**Additions and Renovations
Platt Technical High School
Milford, CT**

ADDENDUM NO. 1

July 23, 2019

1 MEZZANINE FIRE PROTECTION PLAN - AREA E
 1/8" = 1'-0"

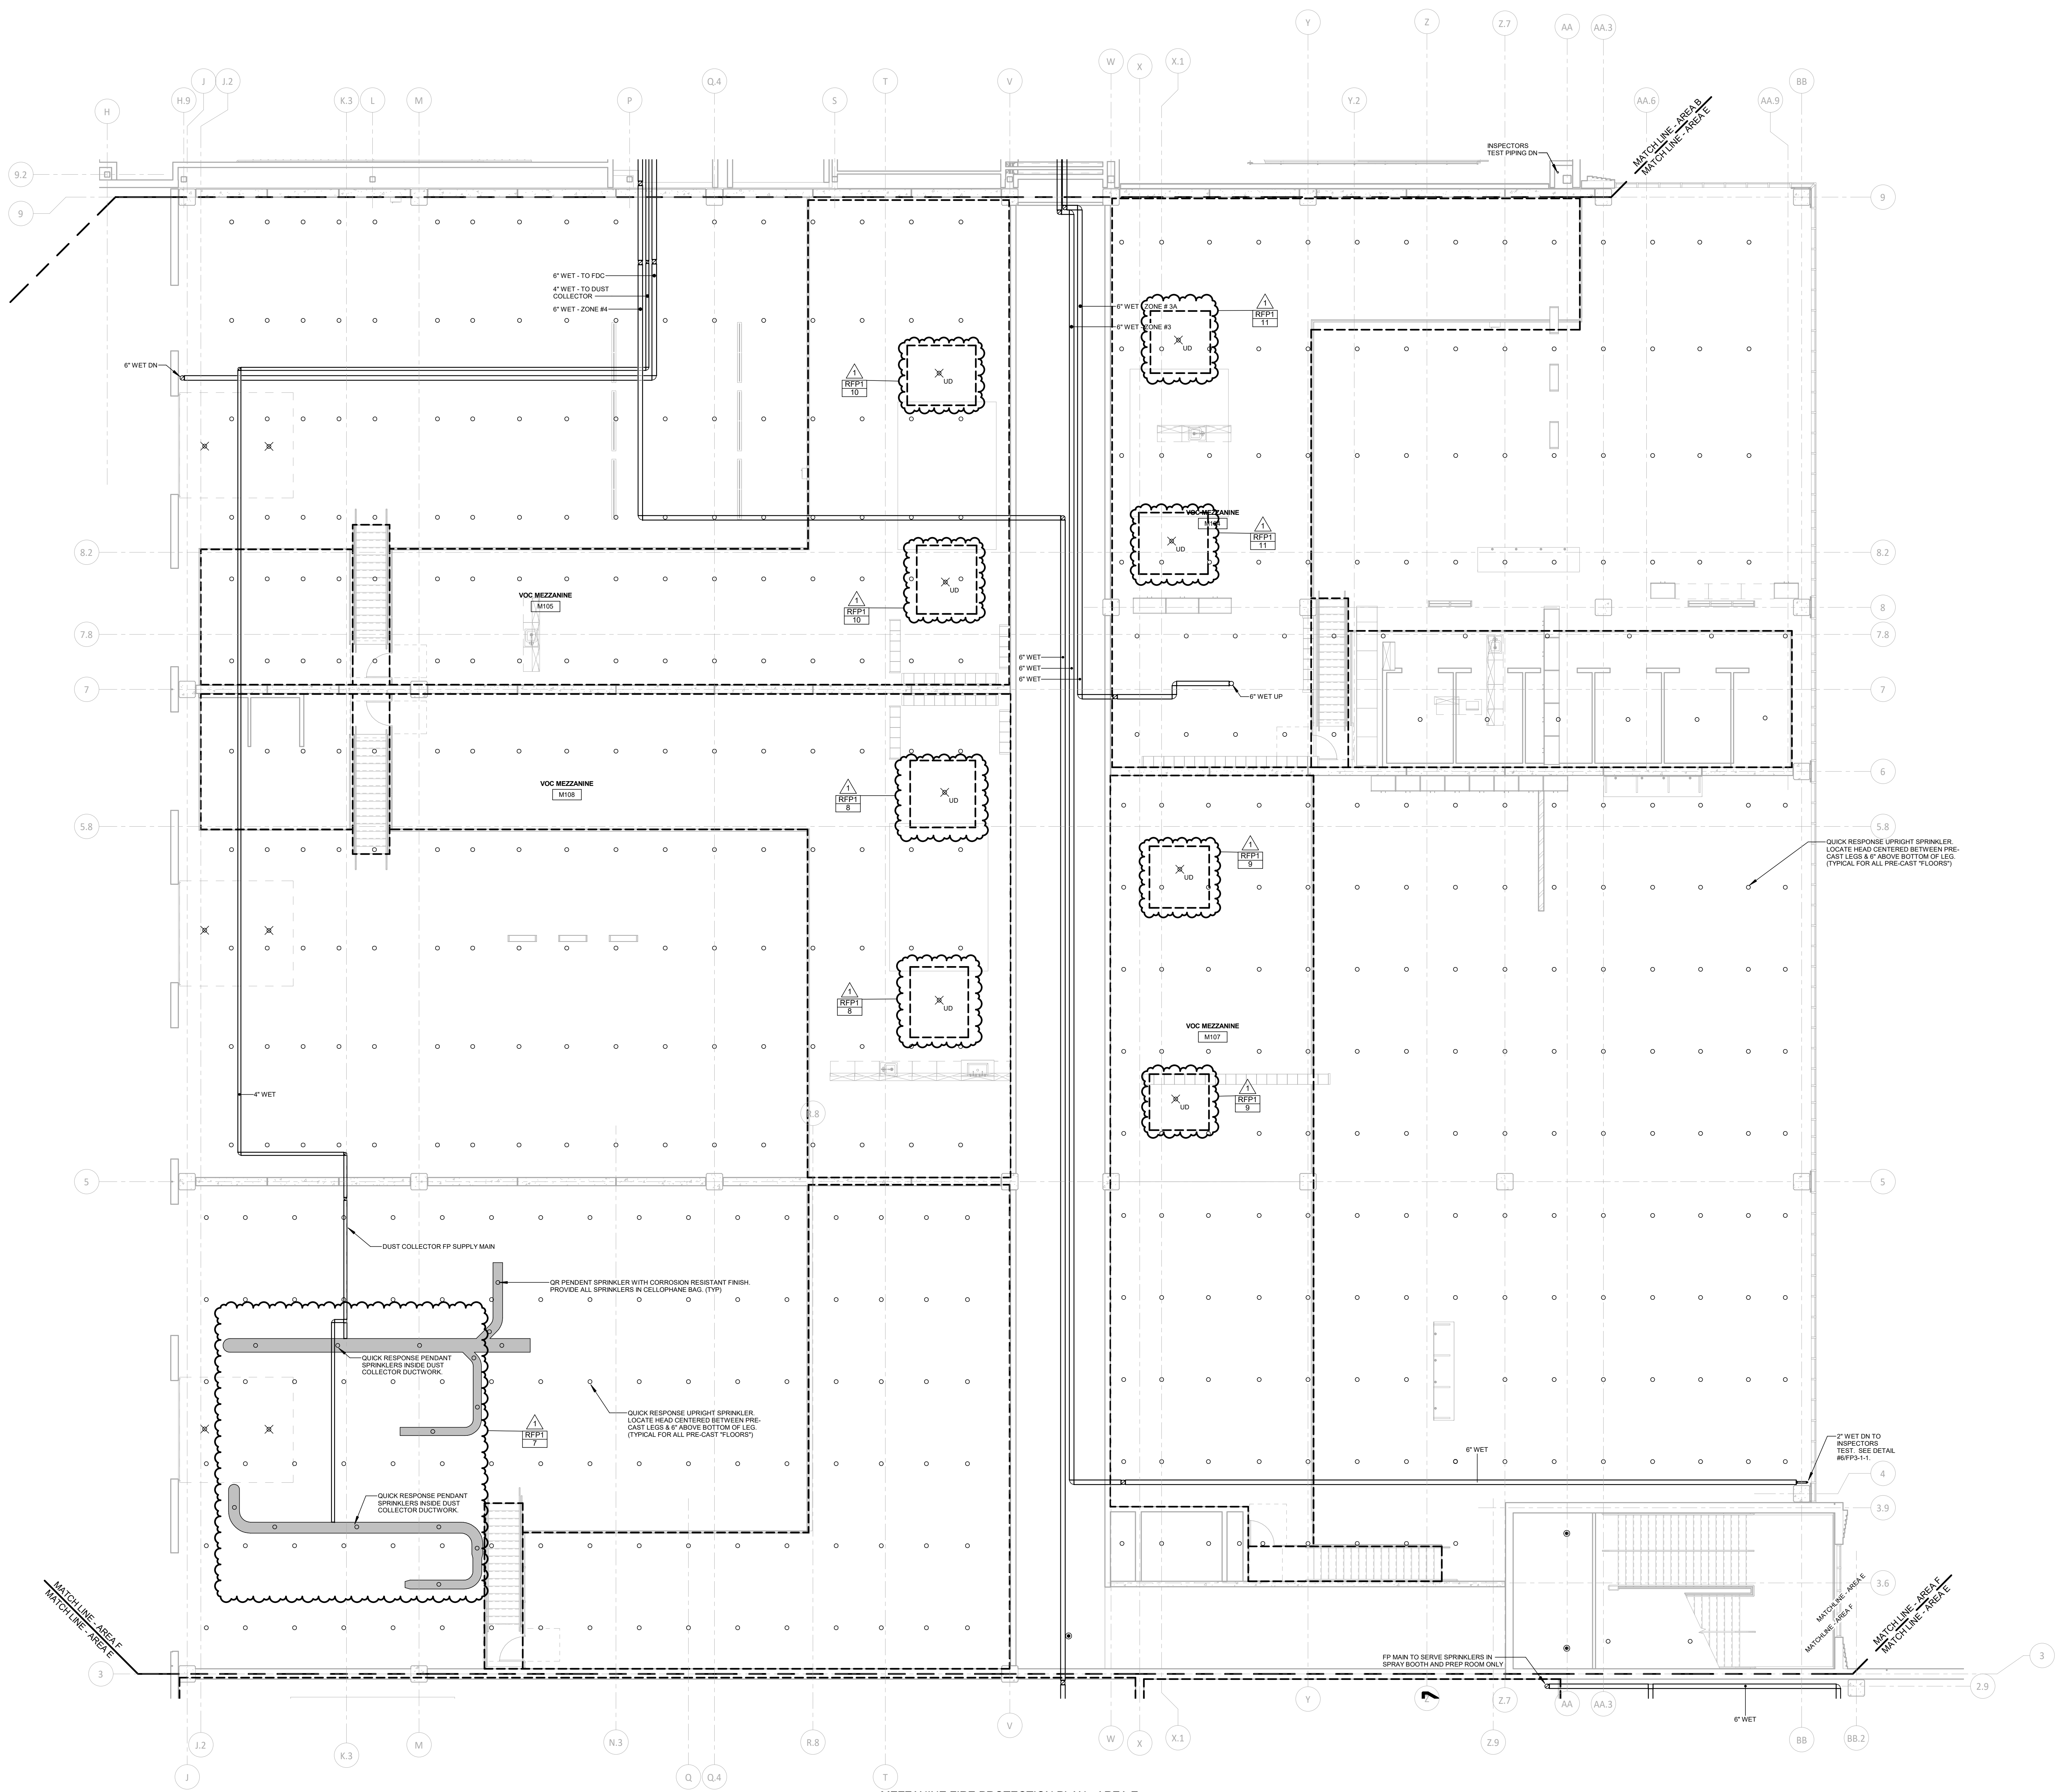
- ADD 1-023 DRAWING FP1-1-ME – MEZZANINE FIRE PROTECTION PLAN – AREA E**
Revised layout for sprinklers protecting dust collection ducts, RFP1-7.
Added sprinklers below ductwork at two mezzanine locations VOC Mezzanine M108, RFP1-8.
Added sprinklers below ductwork at two mezzanine locations VOC Mezzanine M107, RFP1-9.
Added sprinklers below ductwork at two mezzanine locations VOC Mezzanine M105, RFP1-10.
Added sprinklers below ductwork at two mezzanine locations VOC Mezzanine M104, RFP1-11.

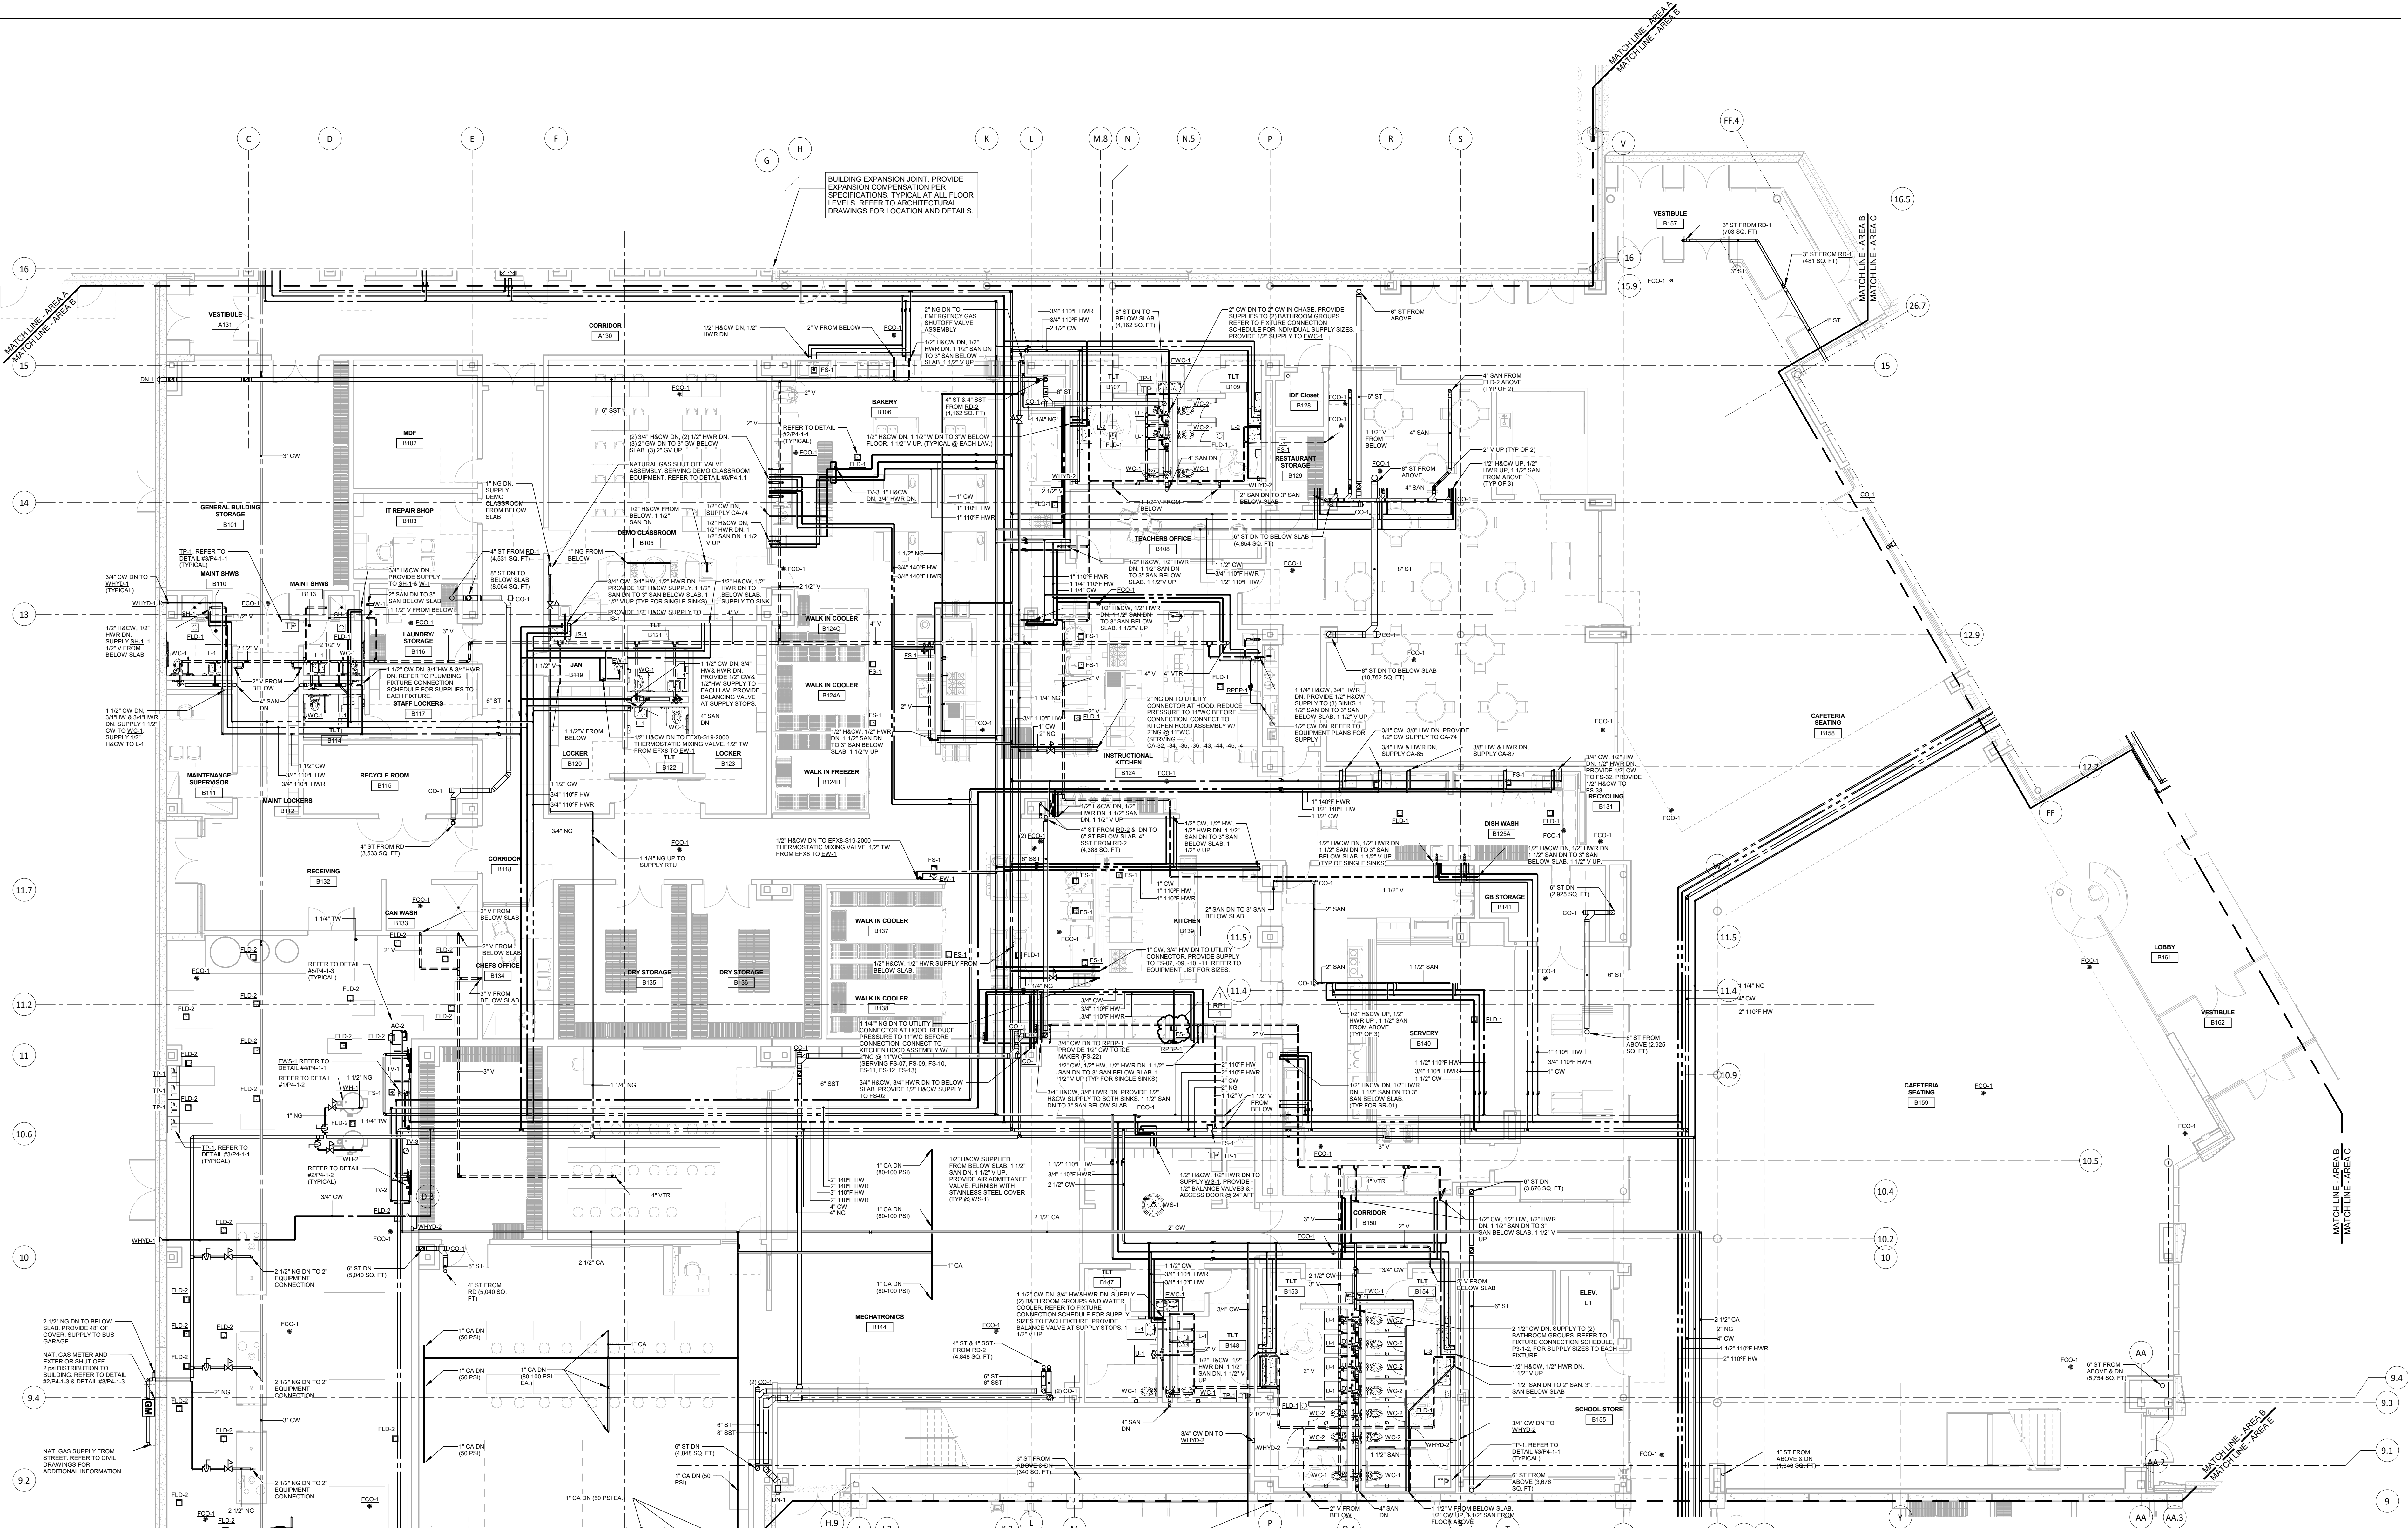
ADD 1-025 DRAWING P1-1-UB – UNDERSLAB PLUMBING PLAN – AREA B
Added FS-1 at equipment #22, RP1-1.
